## PRODUCT CHANGE NOTIFICATION

#PCN-ICC-7MIE-16

Business Unit	Product Line Code	Type of Change	Action	Date of issue
ICC	BE2	Mechanical	Notify Distributors and Field	3/10/2016

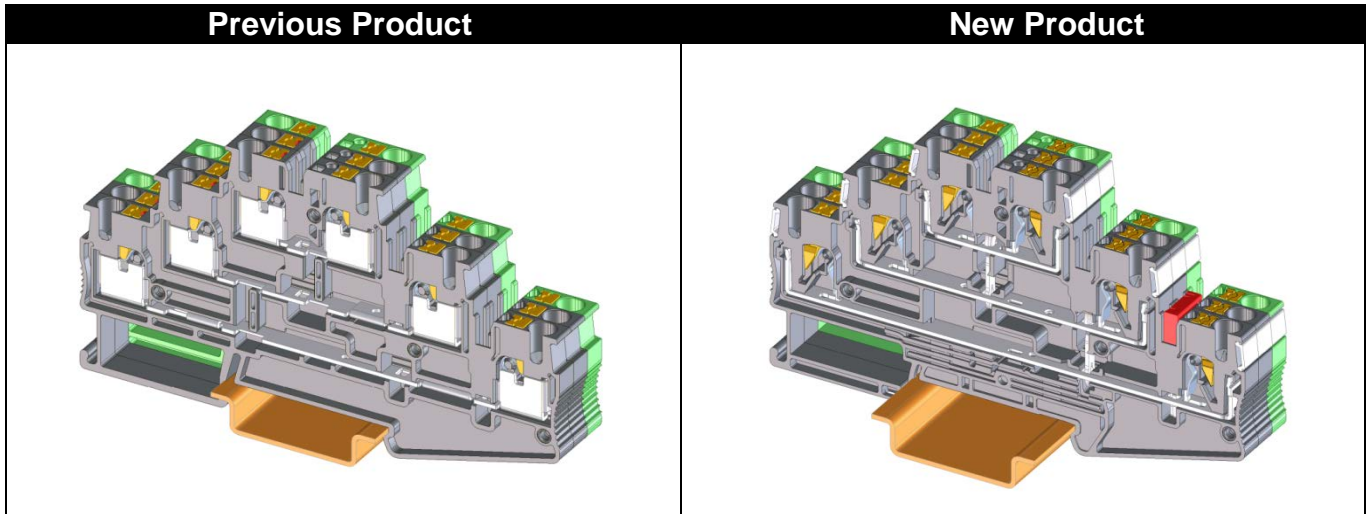
The product change affects the current bar, the push button and the plastic housing. Each of these items has been modified to match our current PT design, reducing the amount of metal needed in each block while retaining the same electrical properties. Changes have also taken place on the PV and PE articles, optimizing the connection between current bars. Due to the change, PT 2,5-3PV (BU) and PT 2,5-3PE are only bridgeable at the lower level. Test connections designed for the bridging shaft will no longer fit the top or middle level, and must be installed on the bottom. Old and new designs are the compatible, the same shape, and can be mixed.
